HISTORIC AND DESIGN REVIEW COMMISSION

HDRC CASE NO: 2022-150
ADDRESS: 504 KING WILLIAM
LEGAL DESCRIPTION: NCB 749 BLK 8 LOT 9,10, NW IRR 28.2FT OF 1 & NW 61.2 FT OF 2
ZONING: RM-4, H
CITY COUNCIL DIST.: 1
DISTRICT: King William Historic District
APPLICANT: Daniel Cruz/Design Coop
OWNER: Christopher Guerra/LAUREL HEIGHTS FAMILY IRREVOCABLE TRUST
TYPE OF WORK: Installation of a wood pergola in the rear yard
APPLICATION RECEIVED: February 28, 2022
60-DAY REVIEW: Not applicable due to City Council Emergency Orders
CASE MANAGER: Rachel Rettaliata

1. Install a wood pergola on the rear balcony.
2. Install a wood pergola at the rear elevation.

SITE PLAN: PROPOSED
SCALE: 1/16" = 1'-0"

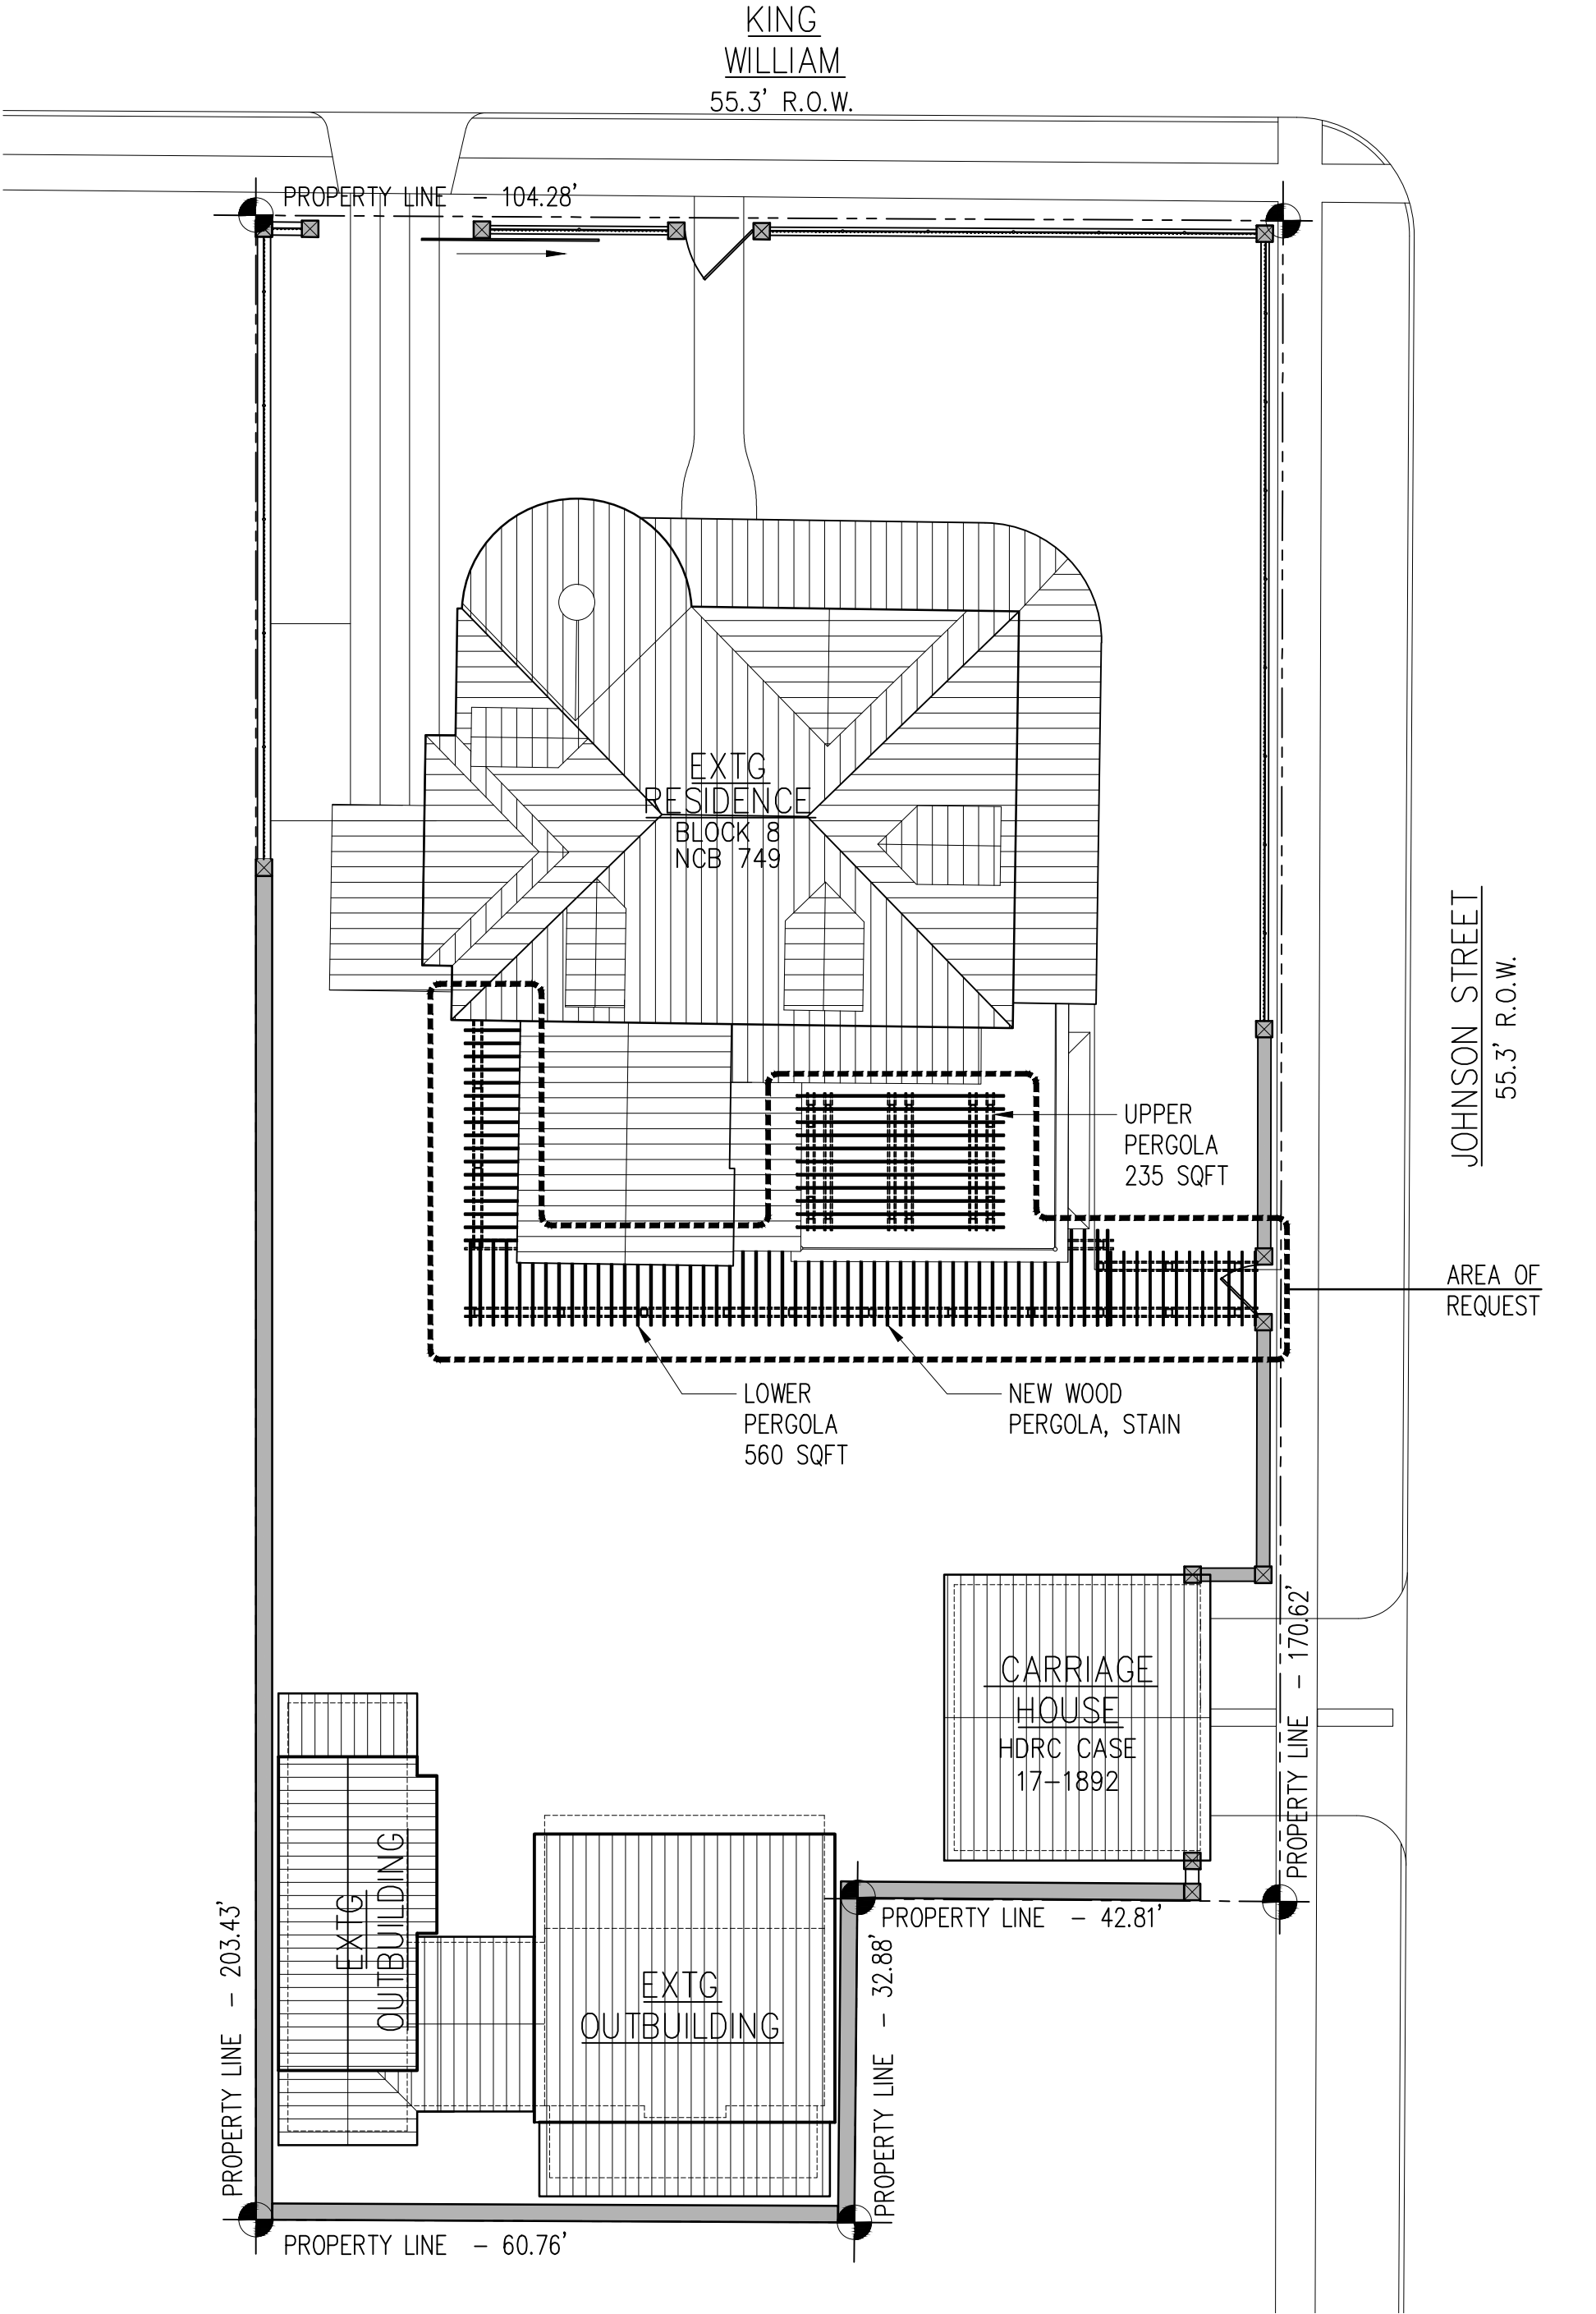
- c. REAR YARD: PERGOLA INSTALLATION – The applicant has proposed to install a pergola in the rear yard along the east (rear) elevation. The proposed pergola is 10 feet, 6 inches in height at the Johnson Street rear pedestrian gate and extends to 13 feet, 6 inches in height. The proposed pergola will total 560 square feet and will connect to the primary structure with a ledger block and threaded rod. The applicant has proposed to install a stone paver walkway beneath the pergola structure. Guideline 3.B.i for Site Elements states that large pavers or other impervious surfaces should not be introduced where they were not historically located. Guideline 3.B.ii for Site Elements states that new pervious hardscapes should be limited to areas that are not highly visible and should not be used as wholesale replacement for plantings. According to Guideline 3.A.ii for Site Elements, do not fully remove and replace traditional lawn areas with impervious hardscape. Limit the removal of lawn areas to mulched planting beds or pervious hardscapes in locations where they would historically be found, such as along fences, walkways, or drives. Low-growing plantings should be used in historic lawn areas; invasive or large-scale species should be avoided. Historic lawn areas should never be reduced by more than 50%. The applicant has not provided the total percentage of lot coverage for review. Additionally, the applicant has not provided a landscaping plan showing the proposed site work. Staff finds that the applicant should submit lot coverage information and a landscaping plan showing the material and dimensions for all proposed site work to staff for review. Staff finds that the requested pergola is appropriate if the condition is reversible and is an independent structure not attached to the primary historic structure.

SECTION: PERGOLA CONNECTION
SCALE: 1 1/2" = 1'-0"

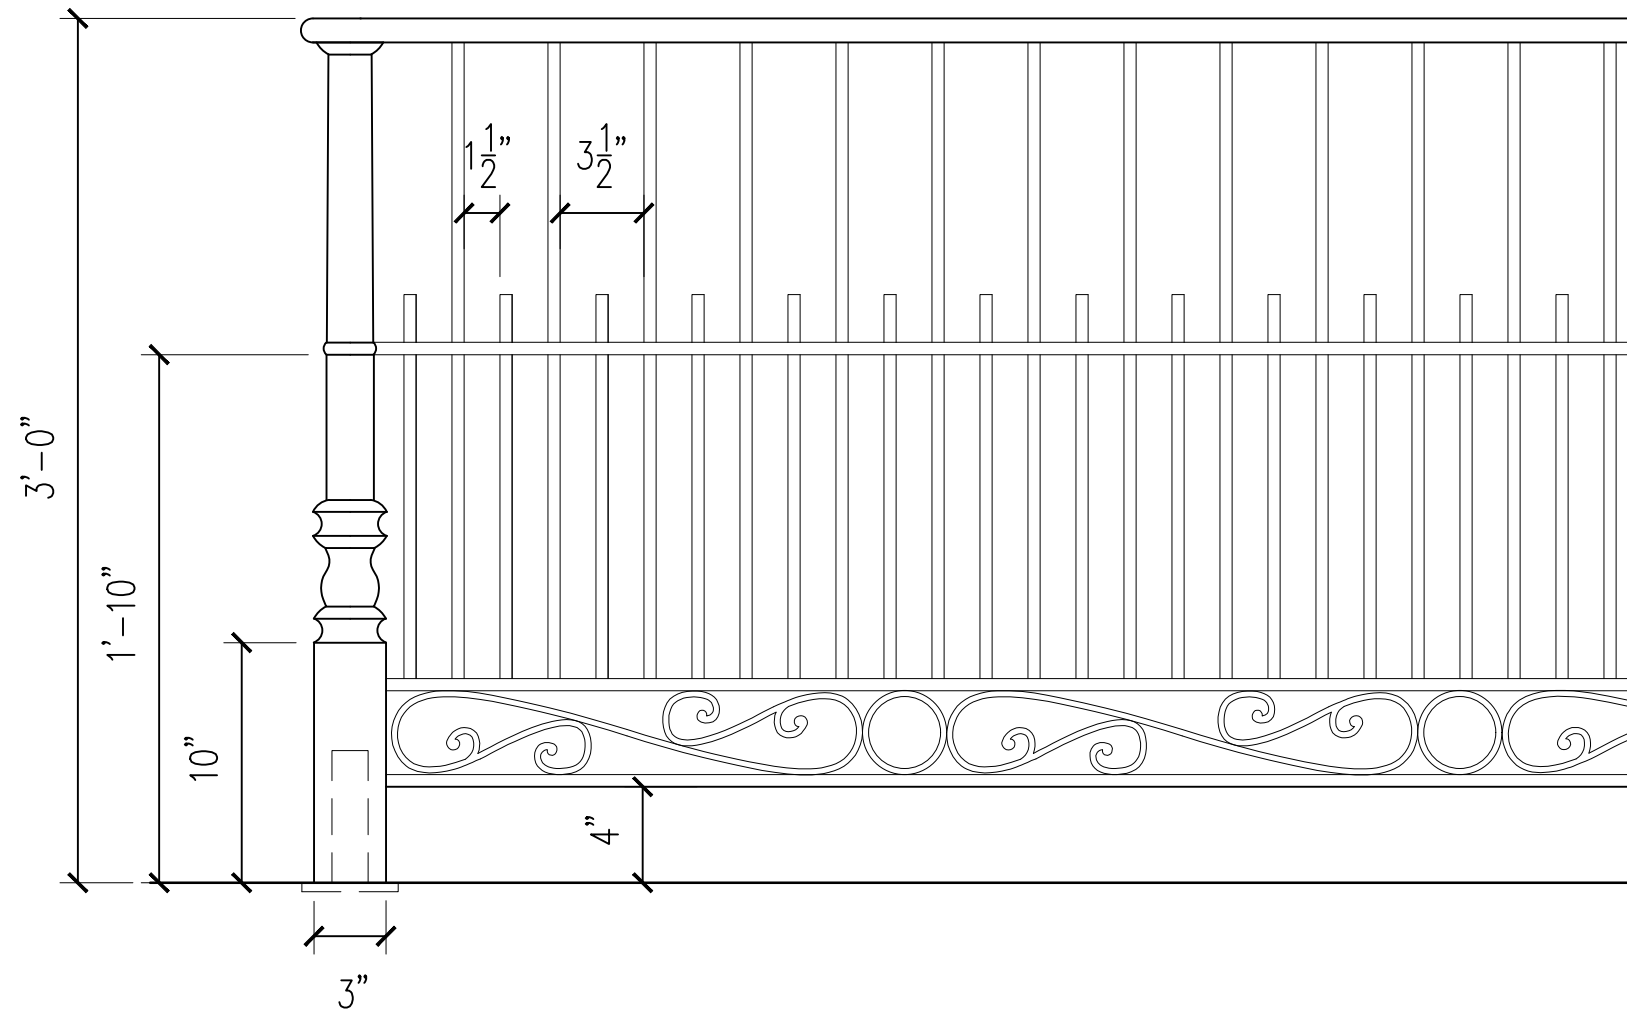
- b. REAR BALCONY: PERGOLA INSTALLATION – The applicant has proposed to install a fully wood pergola on the rear balcony. The proposed balcony pergola is 11 feet in height and will total 235 square feet. The proposed pergola will connect to the primary structure with a ledger block and threaded rod. According to Guideline 1.A.i for Additions, residential additions should be located at the side or rear of the building whenever possible to minimize views of the addition from the public right-of-way. An addition to the front of a building would be inappropriate. The balcony pergola will be visible from the public right-of-way but will not detract from the architectural character of the building. Staff finds that the request is appropriate if the condition is reversible and is an independent structure not attached to the primary historic structure.

- i. That the pergolas are installed so that they are a reversible condition and are independent structures that do not require attachment to the primary structure. The applicant must submit updated installation plans to staff for review and approval prior to the issuance of a Certificate of Appropriateness.
- ii. That the applicant submits a final landscaping plan showing the material and dimensions for all proposed site work and total percentage of lot coverage to staff for review and approval prior to the issuance of a Certificate of Appropriateness.
